# CITY OF ALBUQUERQUE

**Re: Clean Machine Carwash  
4200 San Mateo Blvd., NE  
Traffic Circulation Layout  
Engineer's/Architect's Stamp 6-9-16 (G18-D049)**

Re: Traffic Circulation Layout for 4200 San Mateo Blvd  
87110

A1.1

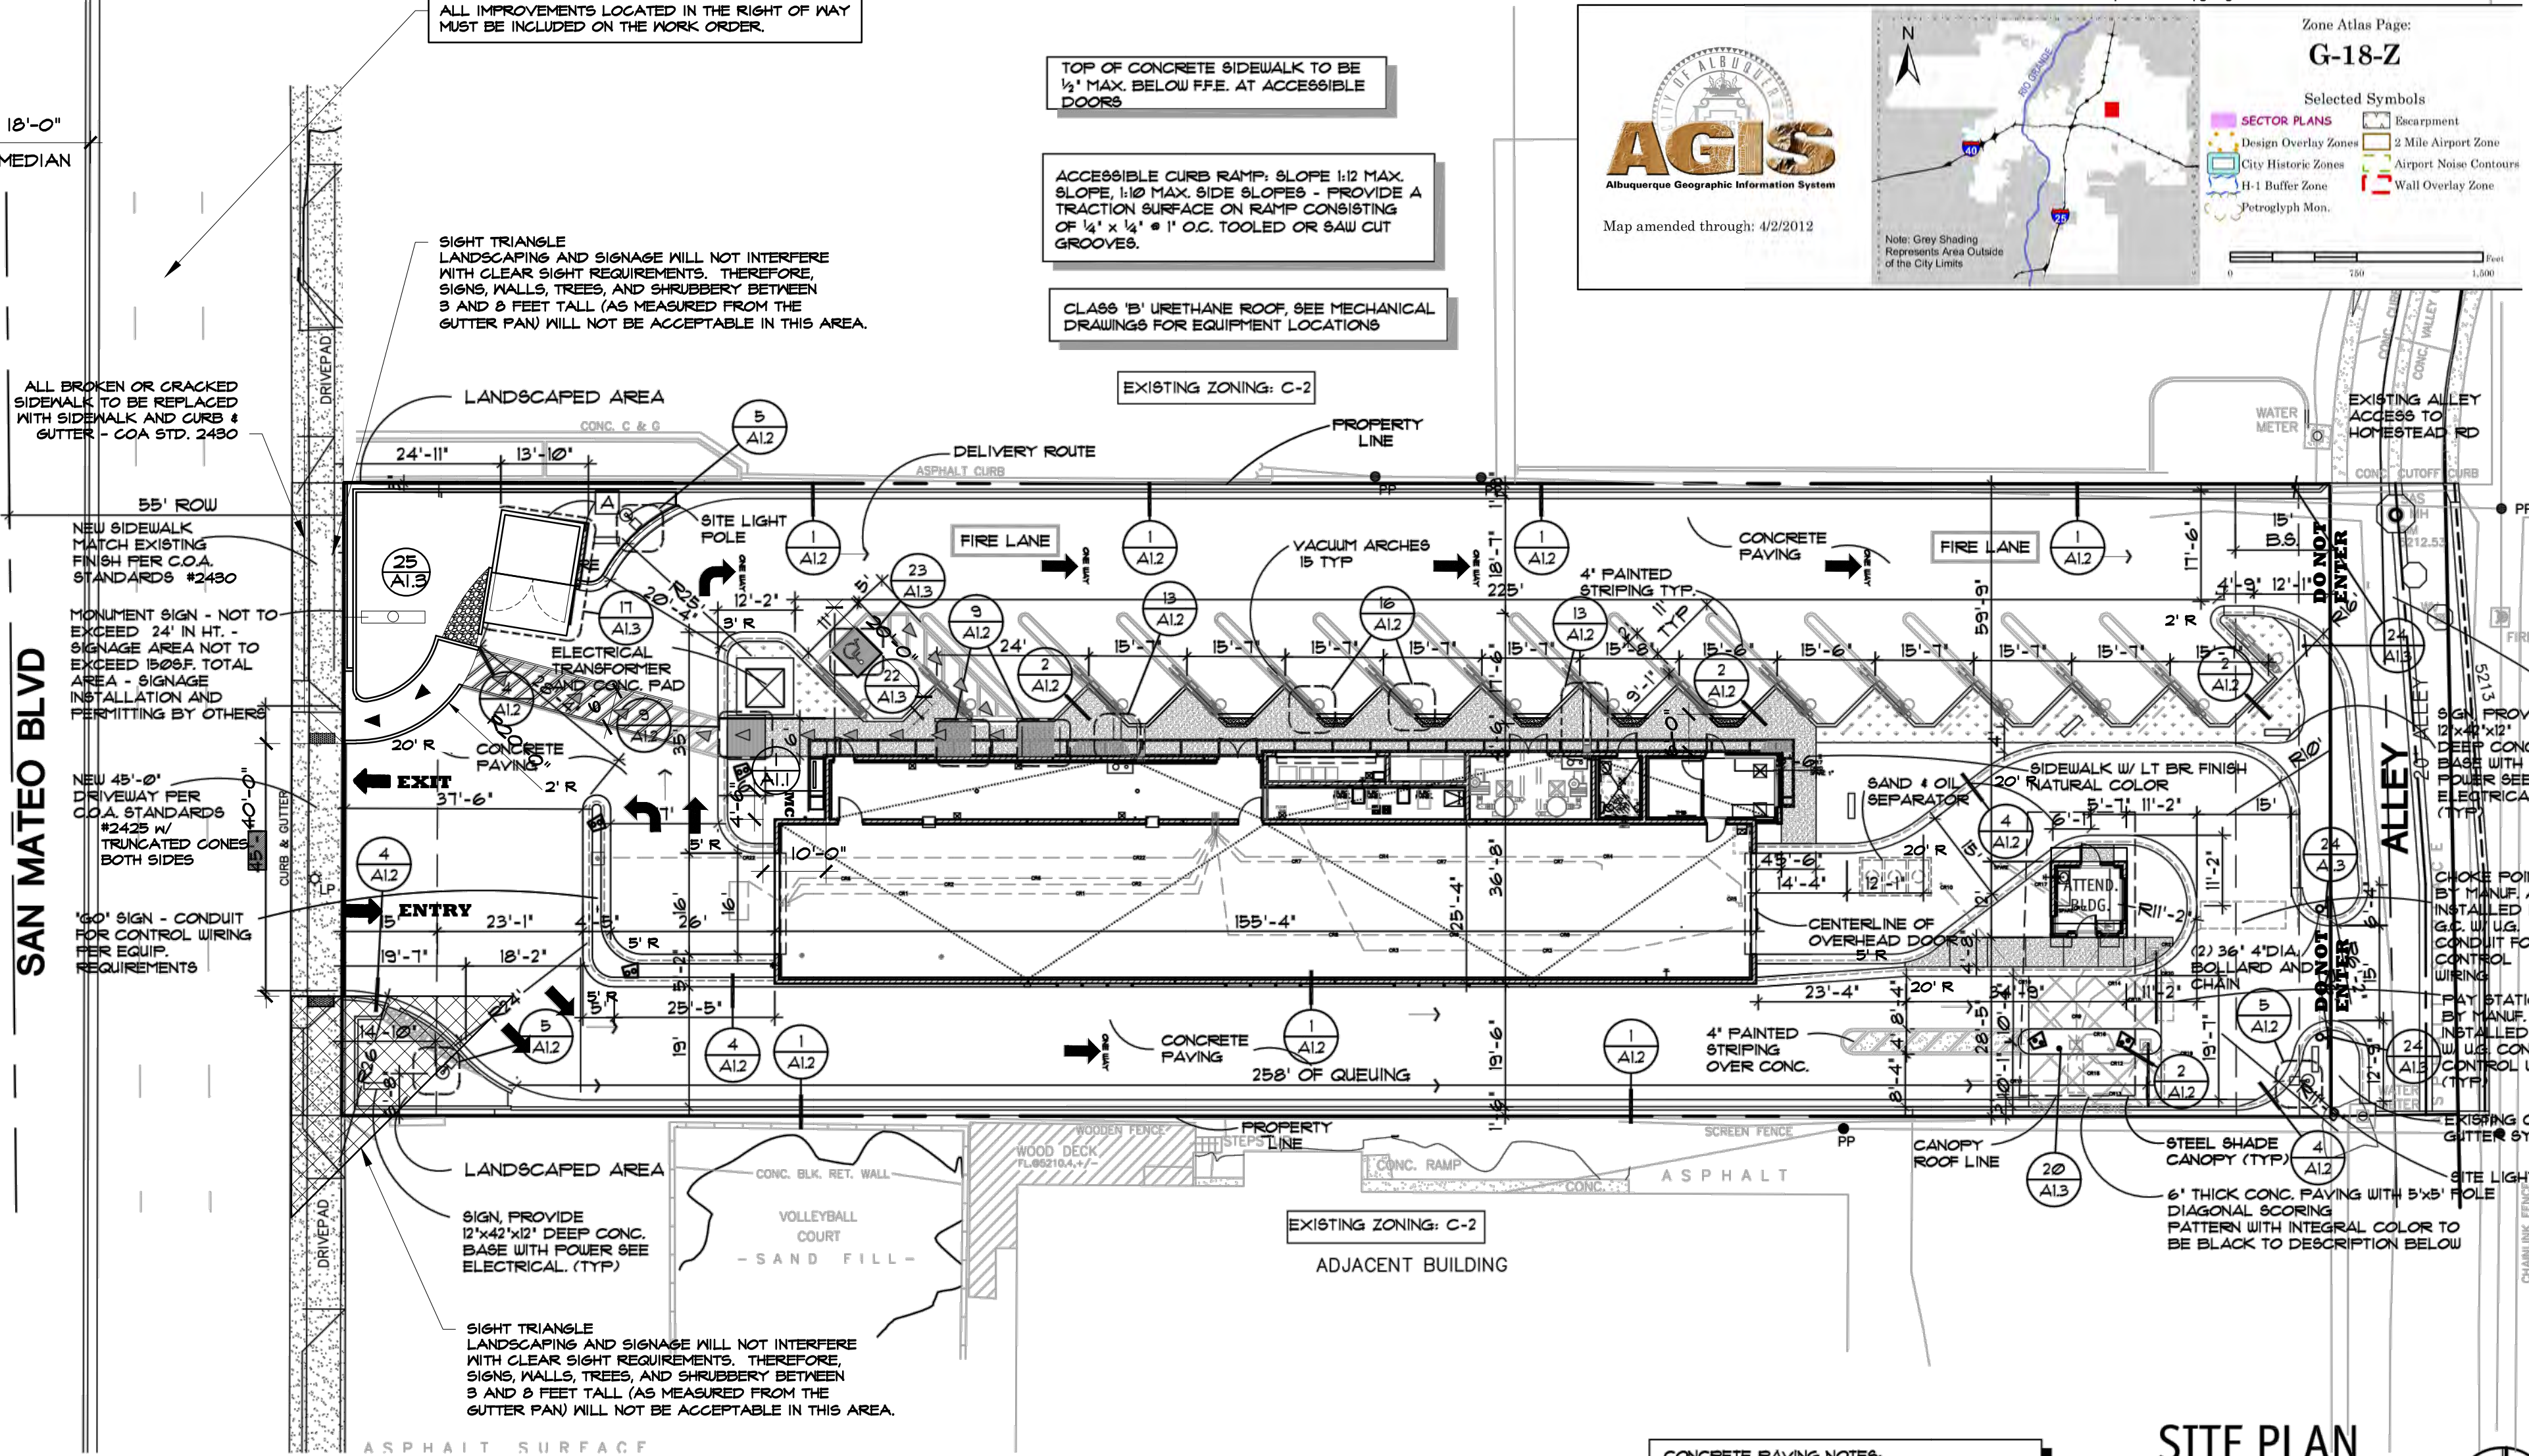
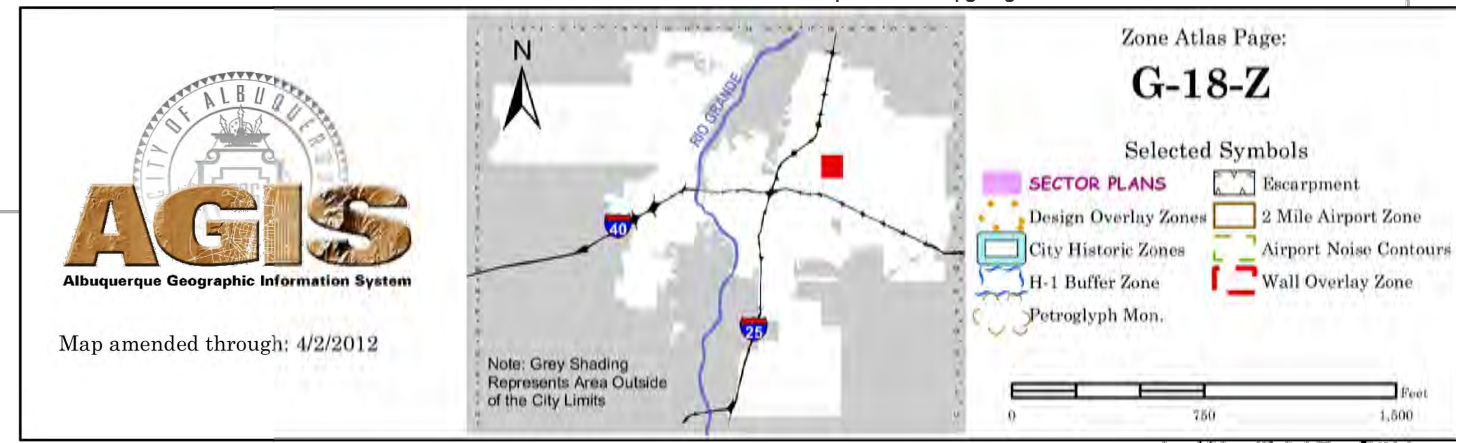
1. Added circulation arrows to plan at entry, Sheet A1.1 and revised the ADA access route to match the new 40' wide drive..
2. Added dimension plan for bicycle and motorcycle parking spaces on Sheet A1.3, Detail 26.
3. Sign note for "Violators are subject to a Fine and/or Towing" shown on Sheet A1.3, Detail 23.
4. Added "Do Not Enter" markings to plan shown on A1.1 and A1.3, Detail 27.
5. City Standard Drawing Numbers shown on A1.1.
